Leeds Flood Alleviation Scheme

**Justification for Change to Material
Finishes at Crown Point Weir**

LFD-ARP-Z1-W1-RP-CC-00001

ISSUE | 5 March 2015

Figure 1: proposed cross section through the weir.

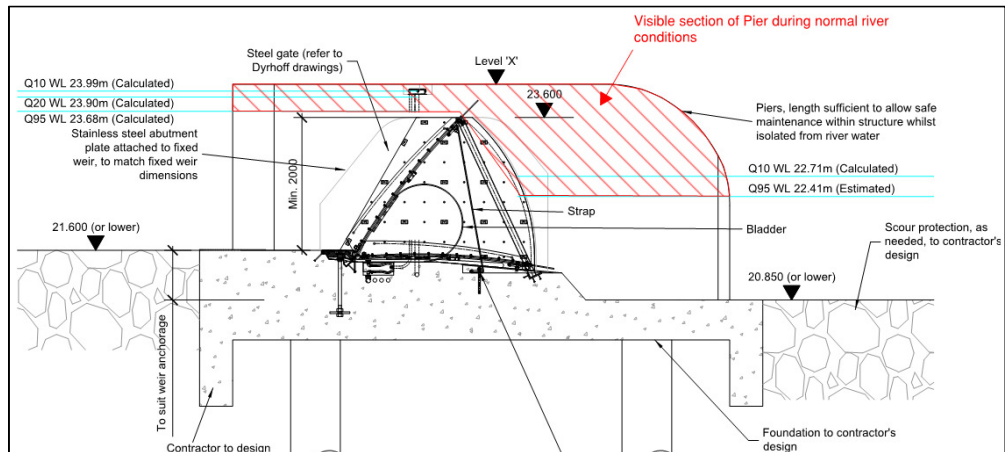
The gates will be predominantly submerged and in normal conditions (Q95) the downstream face and upper 420mm of the dividing piers will be visible (refer to figure 1). **That is to say, under normal river conditions only a limited portion of the pier would be visible.**

The design criteria for the pier and weir gates against accidental impact is 550kN based on a 20 tonne boat impacting the piers at 4.0m/s. This is a low risk event, however debris impact loads are a more likely event with loads in the region of 100kN. This is sufficient to cause damage to masonry finishes.

Figure 2 and 3: Plan and front elevation of proposed movable weir at Crown Point

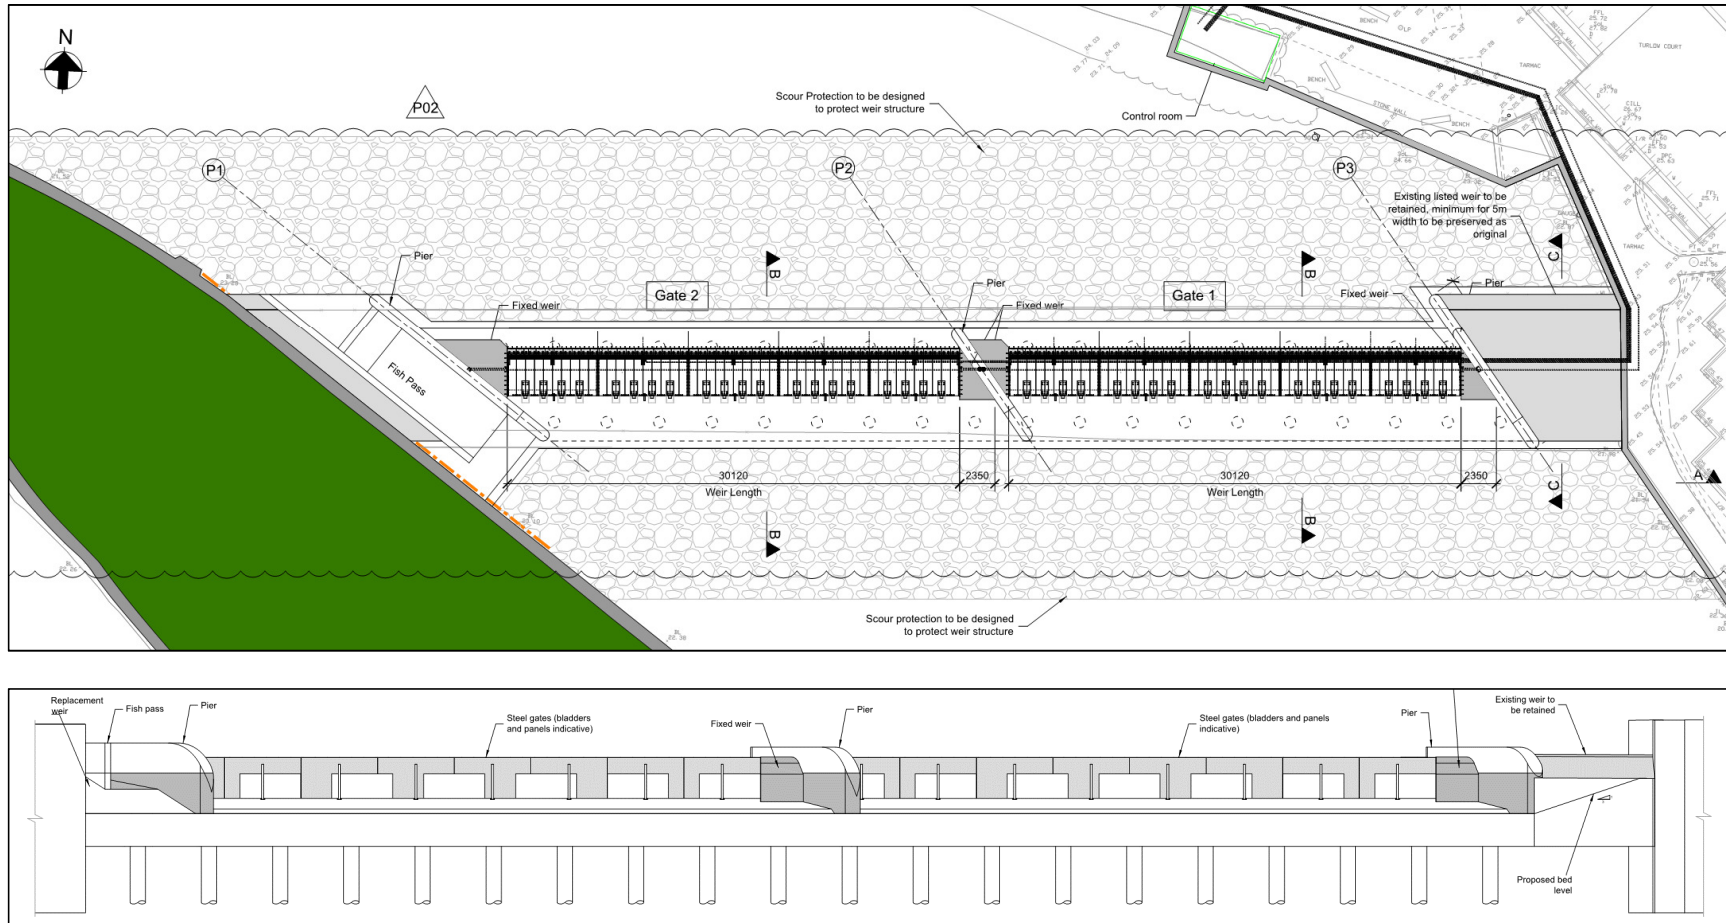
The proposed new weir consists of two movable flood gates, a fish pass and a portion of retained remnant weir. The weir gates comprise painted steel panels supported on rubberised air bladders founded on a concrete apron (refer to the diagram below).
